IN THE UNITED STATES PATENT AND TRADEMARK OFFICE

Appln. No. 10/775,731

FOR: A CONFIGURABLE VOLTAGE GENERATOR

BRIEF FOR EX PARTE APPEAL

FIG. 4A
PRIOR ART

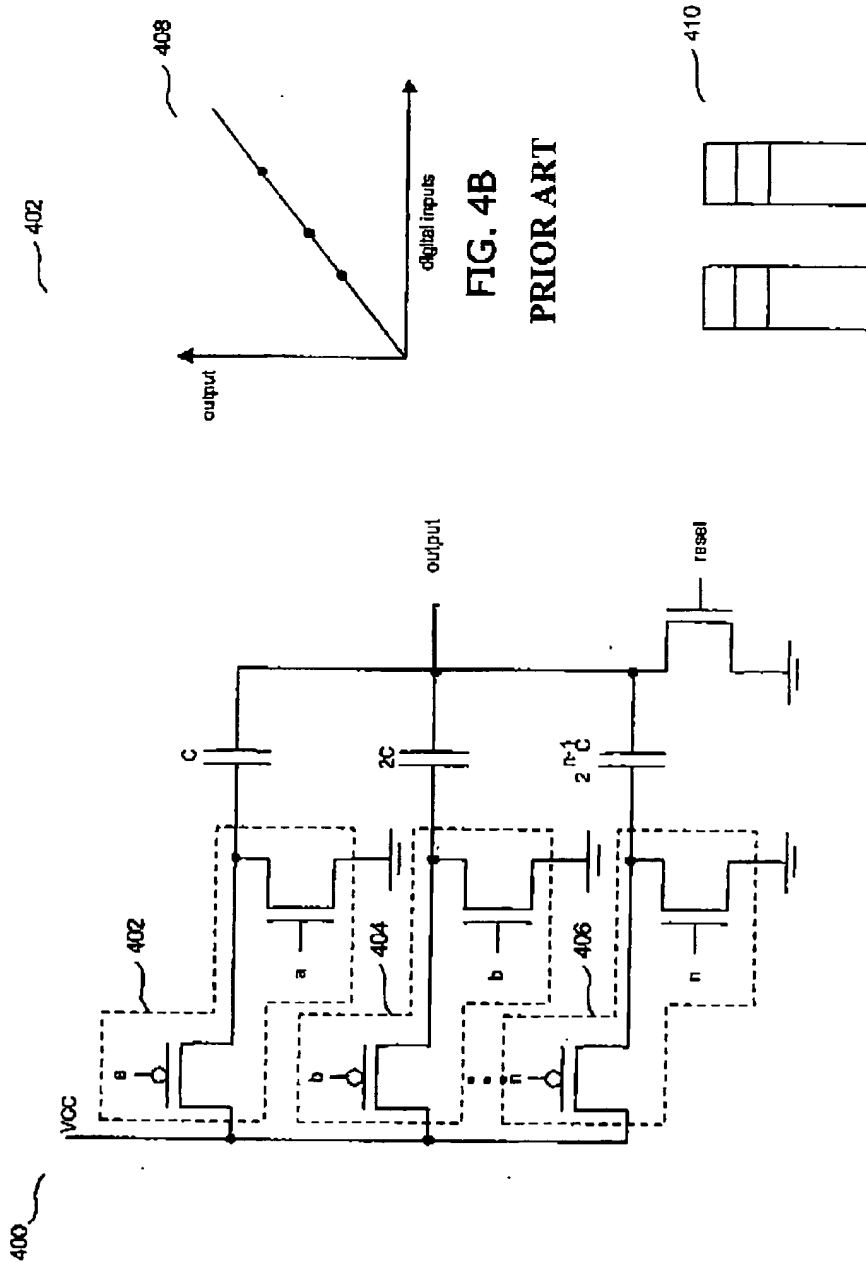
Applicants amended the specification in an Amendment filed May 23, 2005. The Examiner objected to the amendments to the specification, under 35 U.S.C. § 132, alleging that the amendment introduces new matter into the disclosure and has further required the applicant to cancel the new matter. The Examiner further objected to the addition of an output capacitor in Fig. 4a, as adding new matter.

Support for the claims is found on page 7 of the specification. As originally filed, the specification states that “FIG. 4A illustrates a typical n-bit D/A converter, which transforms binary inputs into an analog equivalent. . . .” [0028]. Fig. 4A as originally submitted depicts a prior art D/A converter of the charge redistribution type. This figure is identical to the configuration of Fig. 4-23 of Razavi p. 75, excerpts of which were attached to the applicant’s May 23 amendment and response. Razavi refers to Fig. 4-23 as “a typical capacitor DAC.” Hence that DAC circuit and its operation of converting digital to analog signal levels were well known in the art. Moreover, the output capacitor that applicants had added to Fig. 4a to clarify the DAC’s operation is not necessary for that purpose, and was not required to enable one of ordinary skill in the art to practice the claimed invention. Razavi, Fig. 4-23 does not show such a capacitor, and the DAC 306 sees the capacitance of output capacitor 312 for the full circuit (Fig. 3A). Thus the DAC’s operation is enabled without the addition of a capacitor between elements 306 and 310.

Attorneys for the Applicant canceled the subject matter in a telephone interview with the Examiner. Therefore, the subject matter to which the Examiner objected is canceled, and the objection under 35 U.S.C. § 132 should now be withdrawn.
